**ALBERTA TRANSPORTATION SPRINGBANK OFF-STREAM RESERVOIR PROJECT
RESPONSE TO NRCB AND AEP SUPPLEMENTAL INFORMATION REQUEST 1, JULY 28, 2018**

Approvals
May 2019

9 APPROVALS

Distribution of ABWRET-E Wetland Values in the LAA Using the Alberta Merged Inventory (Version 4.1)

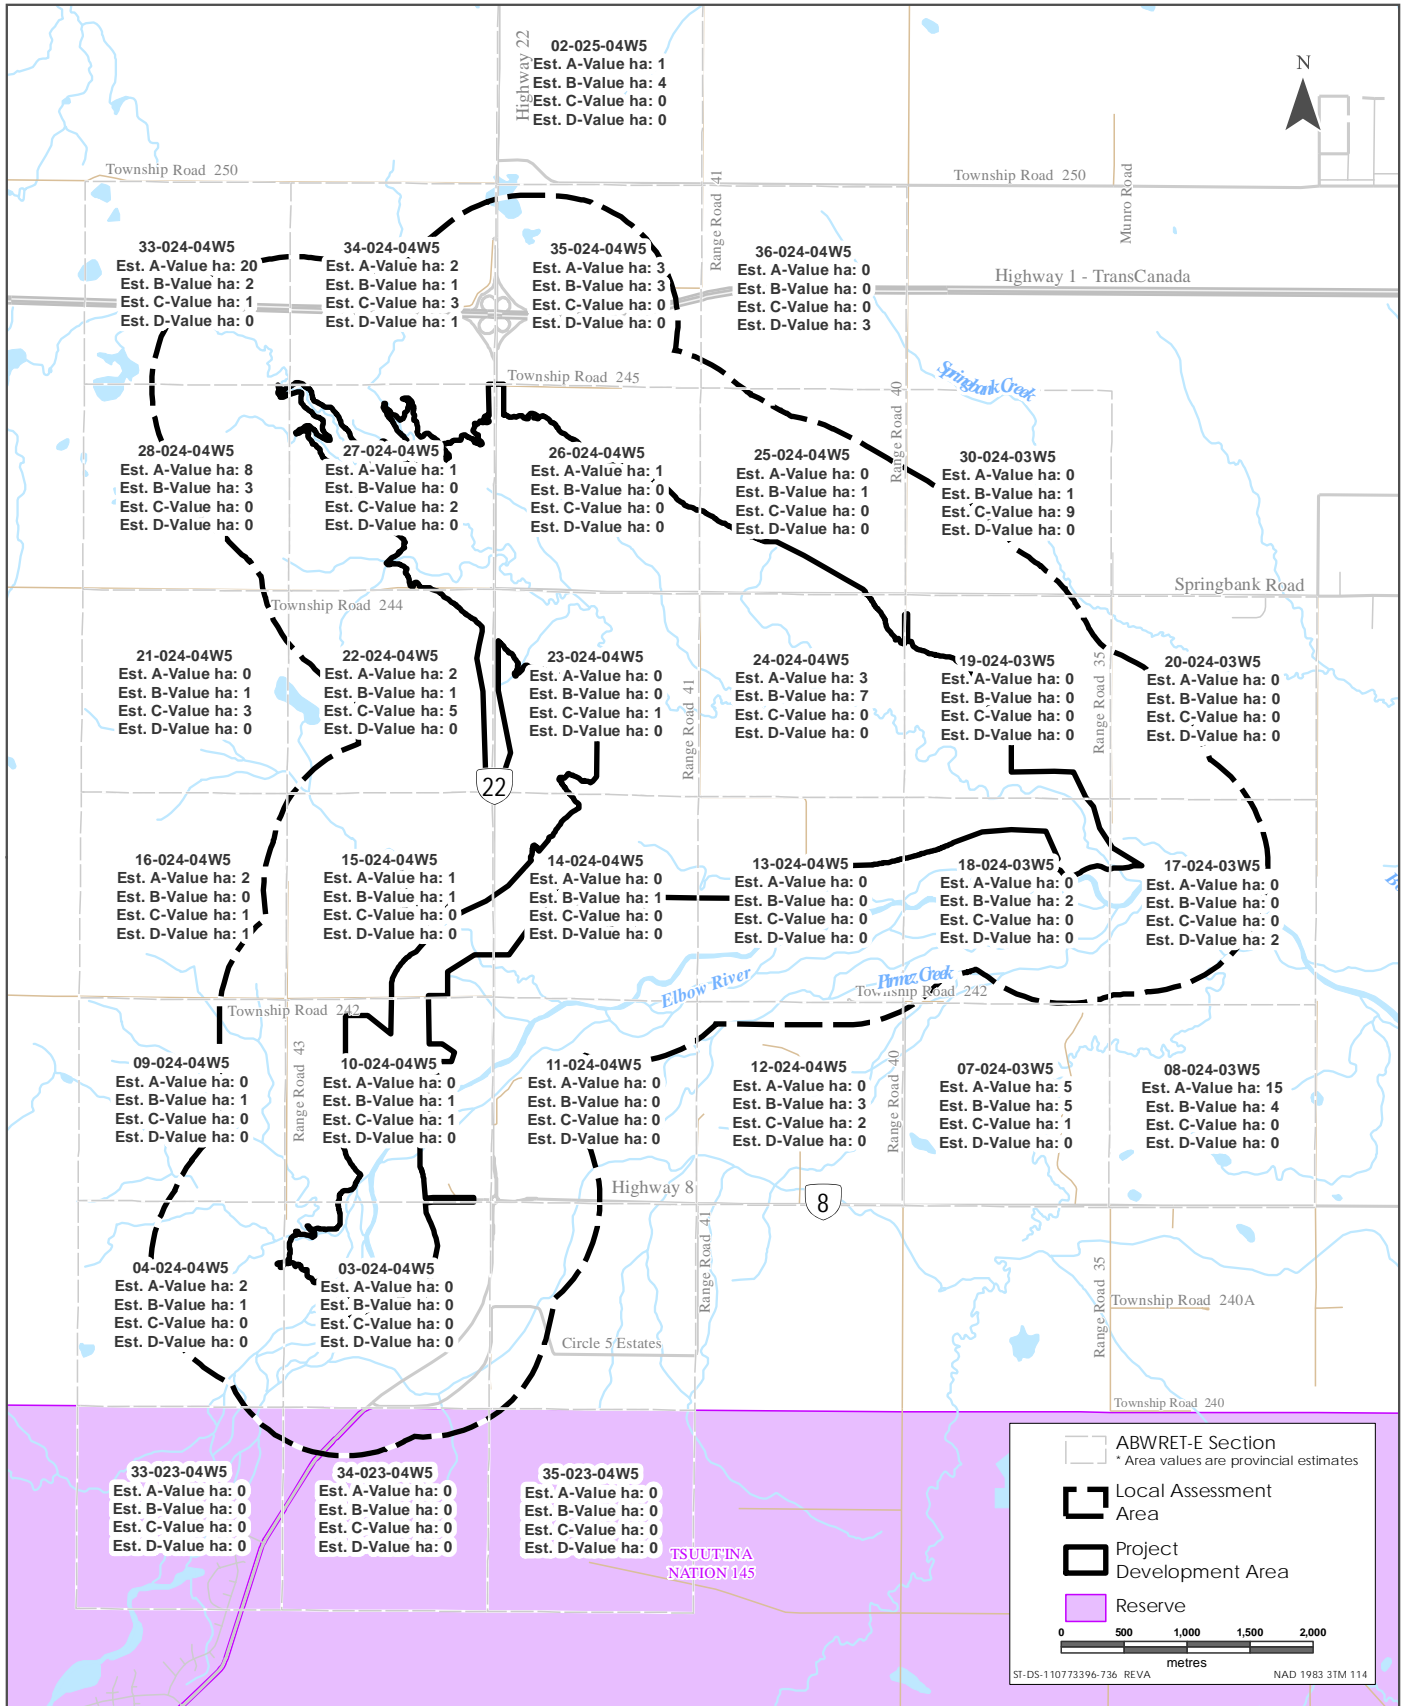
- a. The 108.2 ha of wetlands in the reservoir identified in Volume 3B, Table 10-11 did not appear to have a source and it is inconsistent with the 70.3 ha to be flooded as identified in Volume 3B, Table 10-8. Provide a breakdown of the wetland areas in the LAA, the reservoir, and the area of these wetlands that will be removed by construction and the wetlands that will be inundated by floodwater.
- b. Provide details on the wetland assessment method used to arrive at *estimated* values for wetlands and identify where the valued wetlands are located.

- b. The existing wetland area of 123 ha in the vegetation LAA identified in Volume 3A, Section 10.4.5, Table 10-13 was calculated using the Alberta Wetland Rapid Evaluation Tool – Estimator (ABWRET-E) (GoA 2015). That table provides an estimate of the area of wetlands by value class (A (highest) value, B value, C value and D (lowest) value) for wetlands captured within the Alberta Merged Wetland Inventory by Alberta Township System Version 4.1 for sections intersected by the vegetation LAA. The wetland areas shown in Volume 3B, Section 10.2.4, Table 10-12 (i.e., 15.3 ha) are calculated using the ABWRET-E Alberta Merged Wetland Inventory data, except for sections intersected by the PDA.

The estimated wetland values are summarized from GOA (2015). Wetland areas identified with this approach are not spatially explicit and are not directly comparable to wetland areas determined from Project mapping.

Figure IR530-1 shows the area of wetland value classes by section in the vegetation LAA.

Pipeline Modifications within the PDA

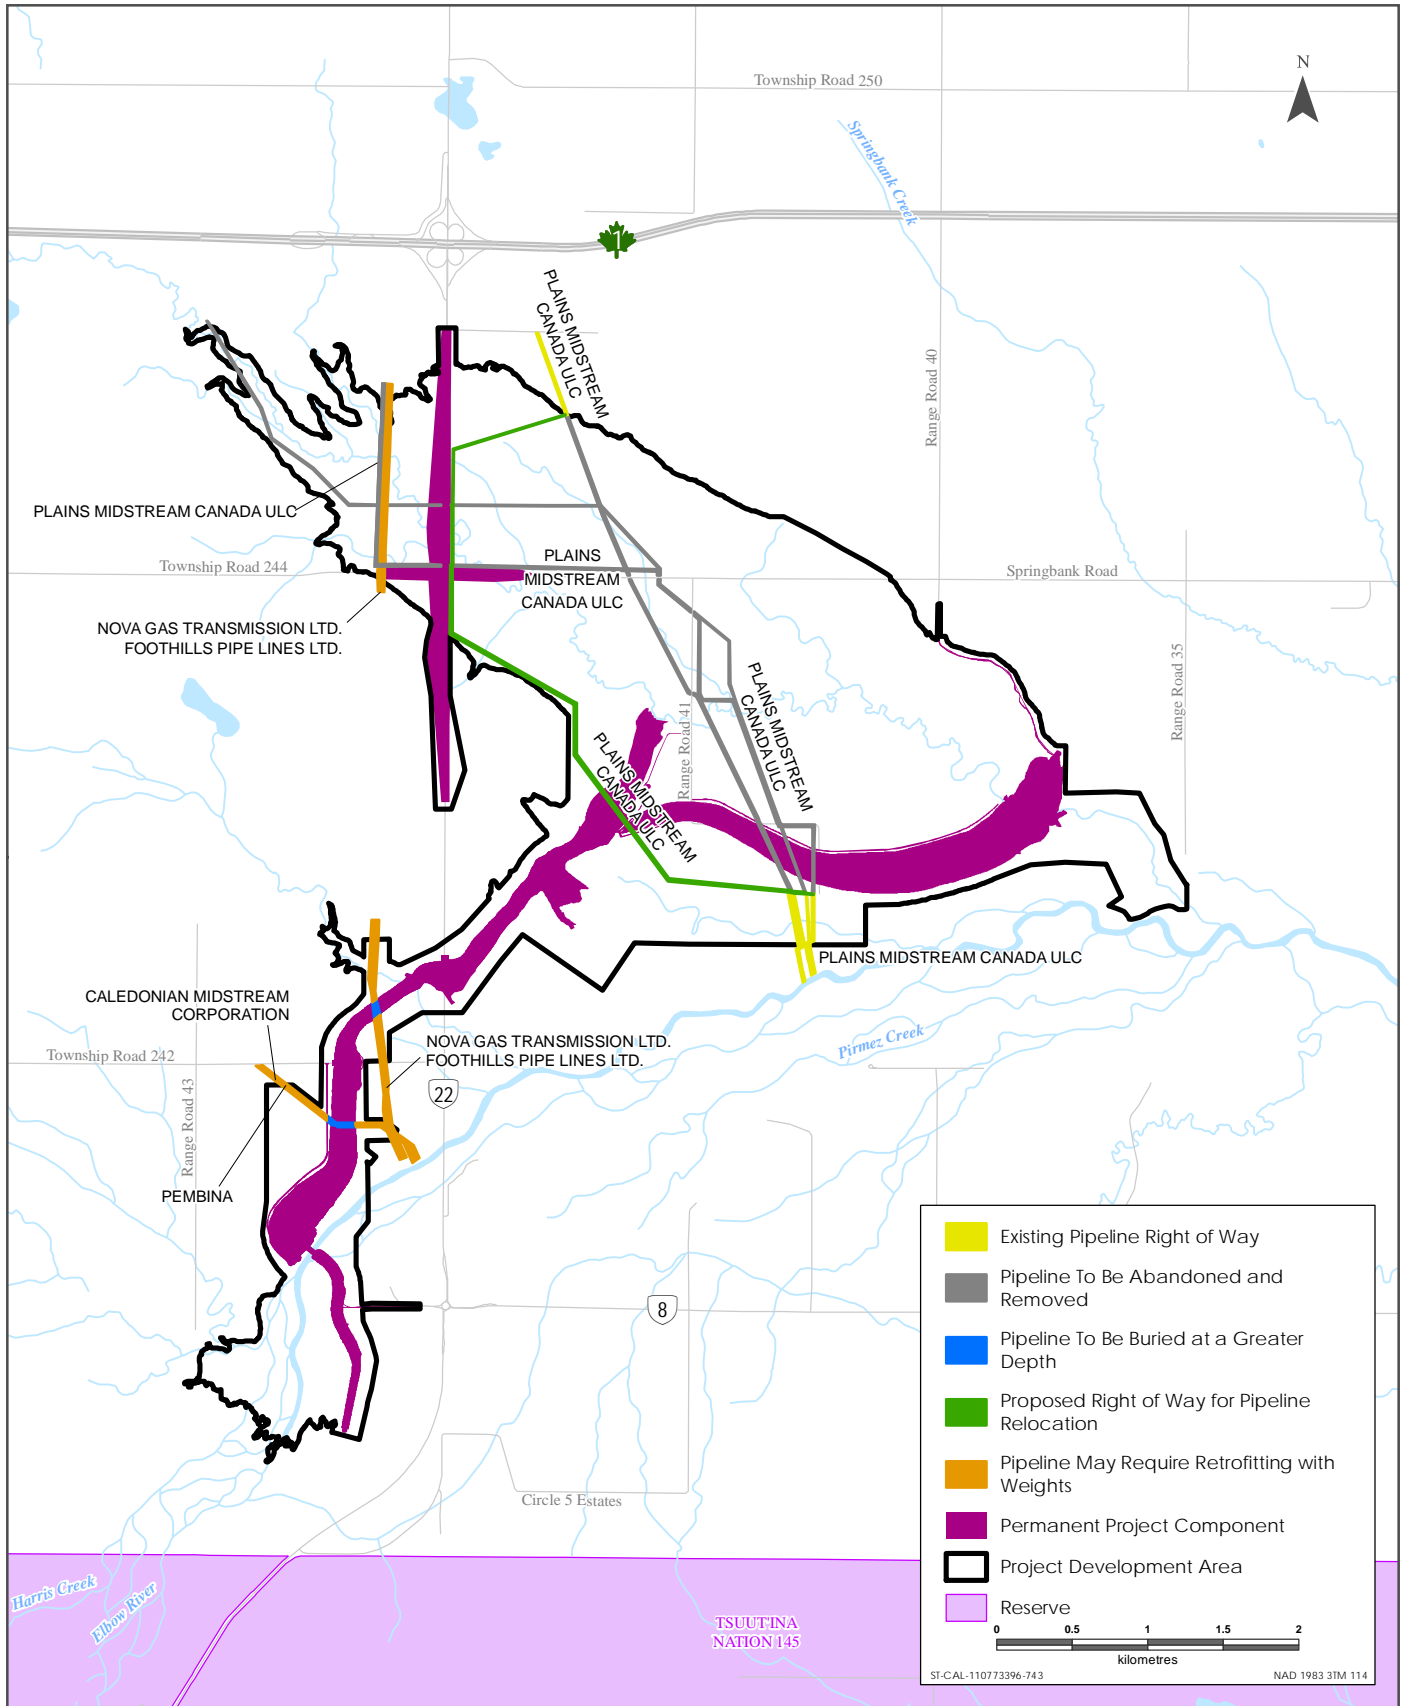
- a. Clarification is required with regard to the relocation and abandonment of pipelines. Describe and provide a sketch of pipelines that will be:
 - i. abandoned in place;
 - ii. removed; and
 - iii. new construction (relocations).
- b. If pipelines are to be left within the reservoir explain the mechanisms for weighting pipe when the pipeline is already buried.

- a. Figure IR533-1 identifies the pipeline modifications within the PDA.

Plains Midstream Canada operates three pipelines (a crude oil pipeline, a low-vapour pressure product pipeline and an abandoned pipeline) that cross the PDA at the deepest part of the off-stream reservoir and pass under the off-stream dam. The pipelines located within the PDA will be abandoned and removed. The two active pipelines will be relocated from their current rights-of-way within the PDA in a loop to the west alongside the east side of Highway 22, and out of the deeper portions of the off-stream reservoir (Figure IR533-1). Pipe weighting may be required in some areas where these pipelines are under water within the portion of the off-stream reservoir flooded at full supply level; weighting requirements are subject to engineering design by the owner.

TransCanada Pipelines Ltd. operates two natural gas pipelines under the entities of Foothills Pipelines Ltd. and NOVA Gas Transmission Ltd. Both pipelines will remain operational and stay in their current rights-of-way (Figure IR533-1). The pipelines in the upper reaches of the off-stream reservoir will likely be retrofitted by weighting while the sections of the pipelines (located in the south portion of the PDA) that cross the diversion channel will be trenched or horizontally directionally drilled to a depth that buries them below the diversion channel by a minimum of 3 m.

Caledonian Midstream Corporation and Pembina operate side-by-side high vapour pressure product pipelines and both pipelines will stay in their current rights-of-way (Figure IR533-1). They will be modified in the same way as the TransCanada pipelines: trenched or horizontally directionally drilled to a depth that buries them to a depth of no less than 3 m where they cross under the diversion channel.
